**Development Permit Resubmission**  
Proposed English Inn Redevelopment  
429 Lampson Street  
May 8, 2017

**Response to Design Review Committee Conditions July 21, 2016**

**Deer Management Plan**  
Response to Design Review Committee Condition 3

**Light Management Plan and Rationale**  
Response to Design Review Committee Condition 4

**Site Circulation Plan**

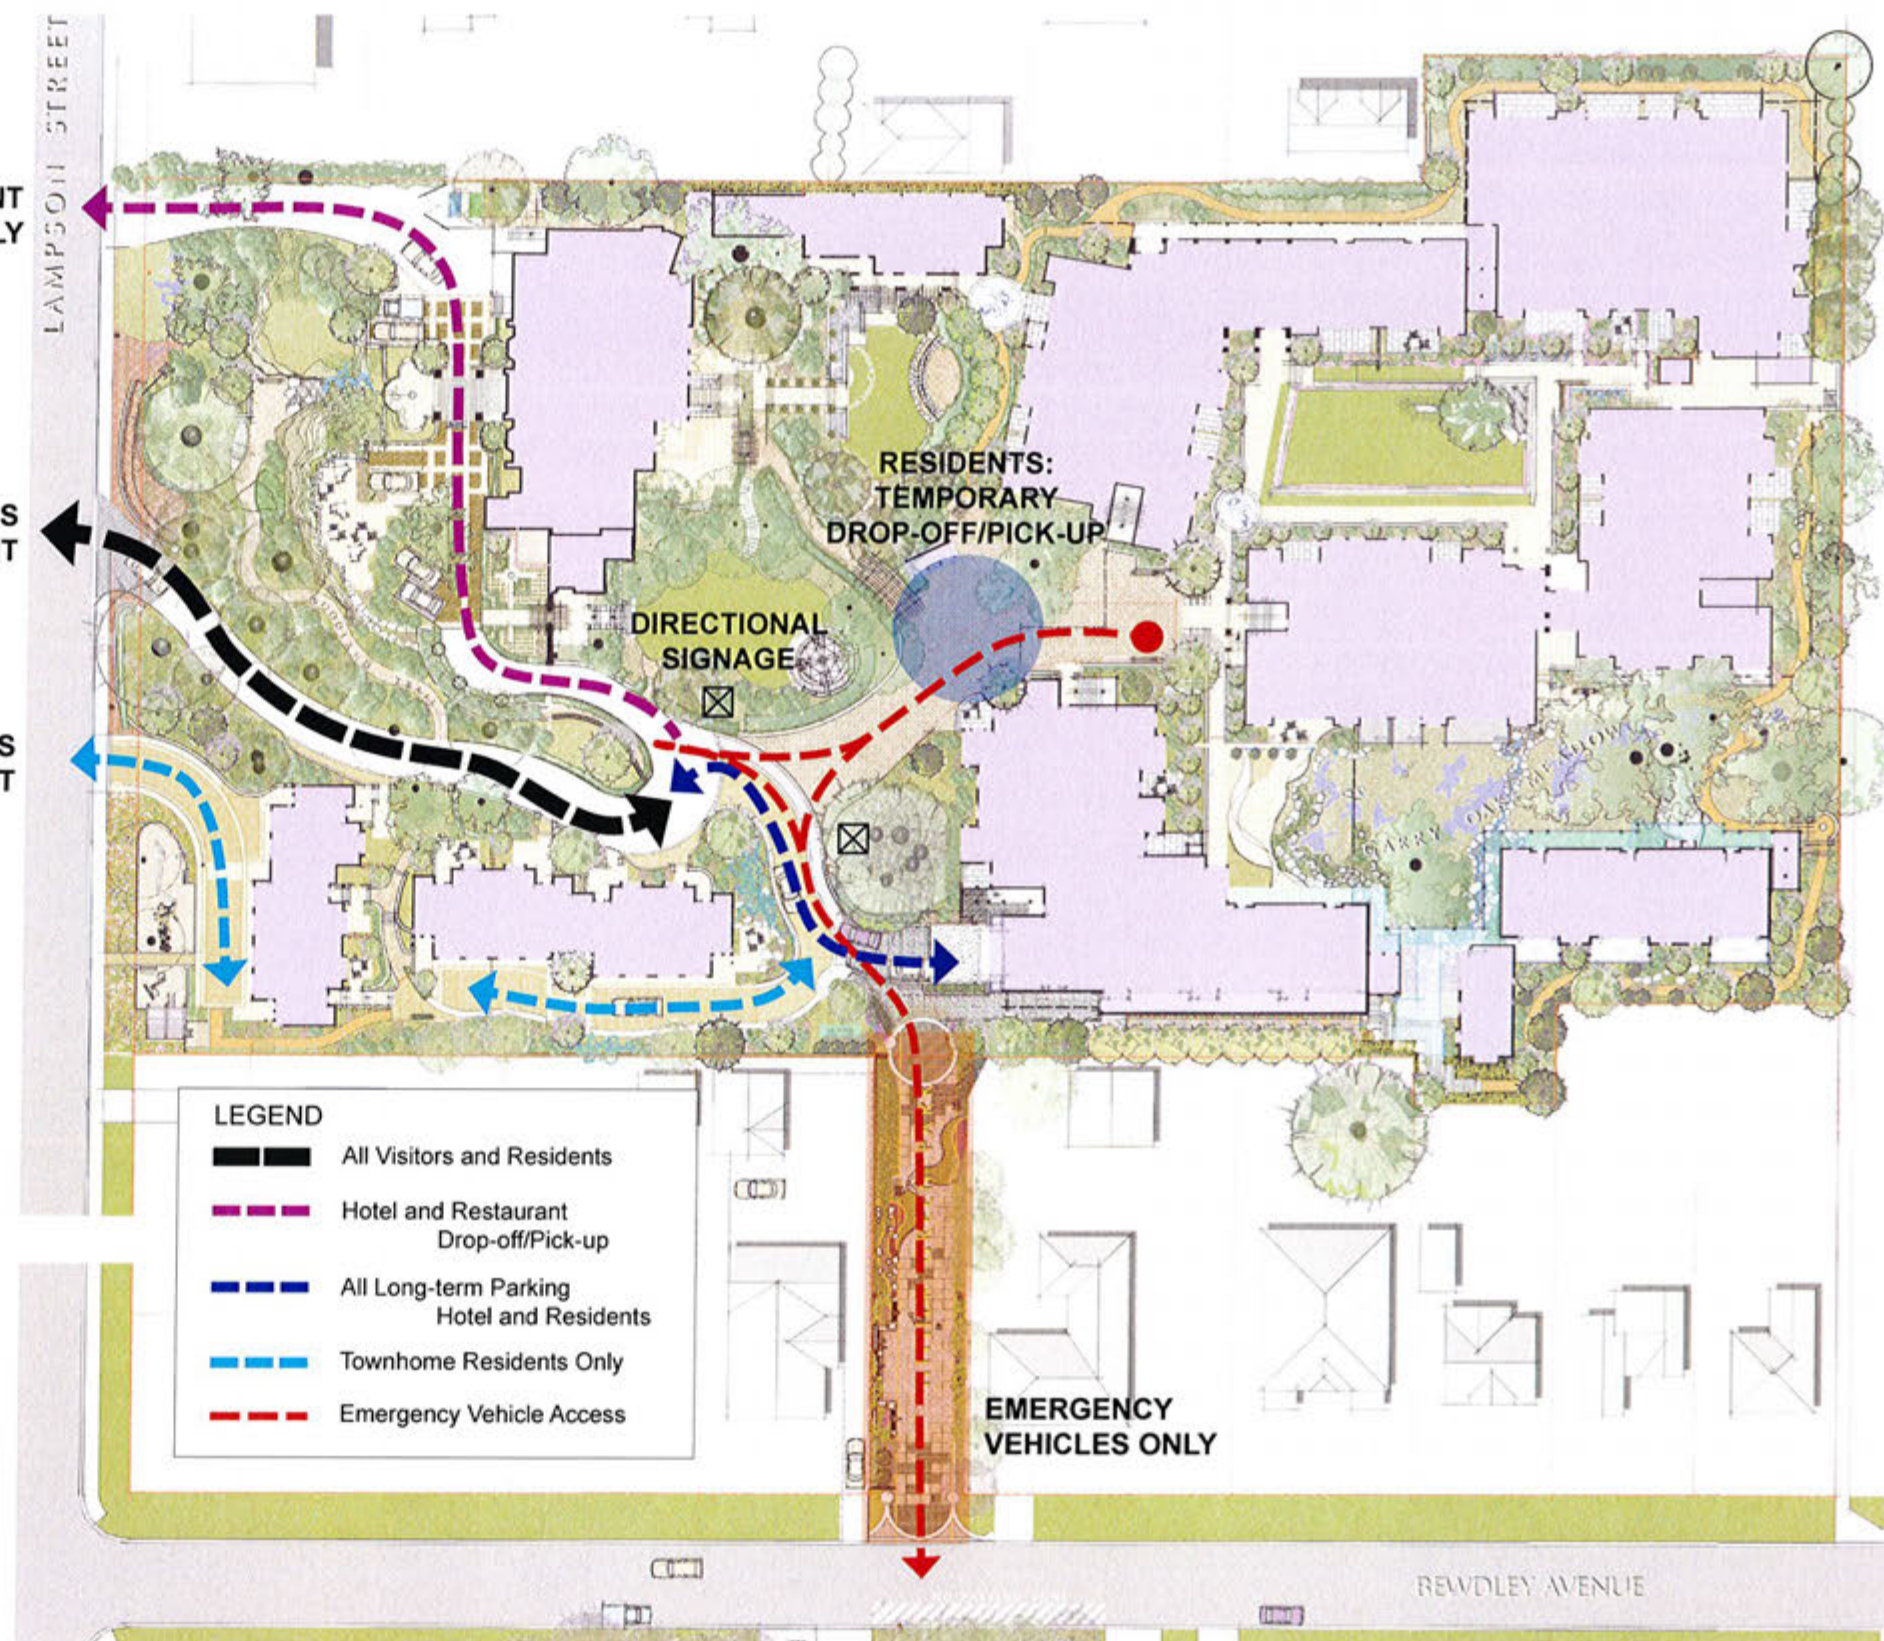
- Please see Exterior Corridor Condition Perspective Views, attached.
7. Provide clarification on approaches, drop off zones and general circulation to the east portion of the site.

The management of vehicle circulation through the English Inn site is limited by the existing access road and the orientation of the deep site with a single frontage along Lampson Street. The intent of the site design is to minimize the introduction of new roadways so as to preserve the existing landscape to the extent possible and create a quiet, green retreat. The proposed design is intended to enhance pedestrian access throughout the entire site, with access points off Lampson Street through the preserved gardens of the English Inn, and via the new public park at Hither Green. A footpath around the perimeter of the site acts as a landscape buffer to the neighbouring properties as well as an emergency exit route.

Vehicular circulation for all residents and guests is restricted to the western half of the site. The existing access lane is preserved as a two-way entrance and exit and cannot be significantly altered without risking the health of the adjacent trees. Sensitive-placed pull-offs (permeable to respect root zones) will facilitate and improve vehicle bypass. Motorists will arrive at a 3-way junction at which point clear signage will indicate short term parking for the Inn to the left along the existing one-way lane, and long term parking and residential parking to the right, along a new two-way lane. Short term parking for residents is located off the lane to the parkade. Signage will be primarily to serve Inn guests, as residents will be aware of where their secure parking is located.

Emergency response vehicles will be able to drive through Hither Green to the emergency response kiosk at the centre of the site, where a site-wide annunciator and a fire hydrant will be located. A required hammerhead turnaround for emergency vehicles has been integrated into the vehicle circulation paths to the satisfaction of the Esquimalt Fire Department.
